DATE: April 4, 2016 ST-001-16

SUBJECT: LX Series Package Heat Pumps and Split System Heat Pumps
Defrost Control Boards

SAP: 1111162 / S1-03103483000
Used on the LX package heat pumps

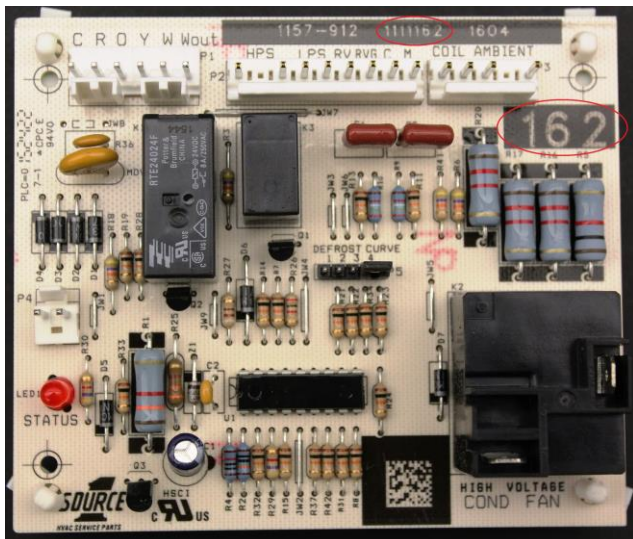
The new LX series package and split system heat pumps use a visually identical defrost control board. The purpose of this ST letter is to make the field aware that although they look identical, they do have different defrost curves programed in them and **are not interchangeable**.

As you can see in the images above, the boards appear identical; however, in the black box in the top right quadrant of the control a three digit number is present that is used as an identifier.

- The “162” is used on LX series package heat pumps
- The “009” is used on LX series split heat pumps
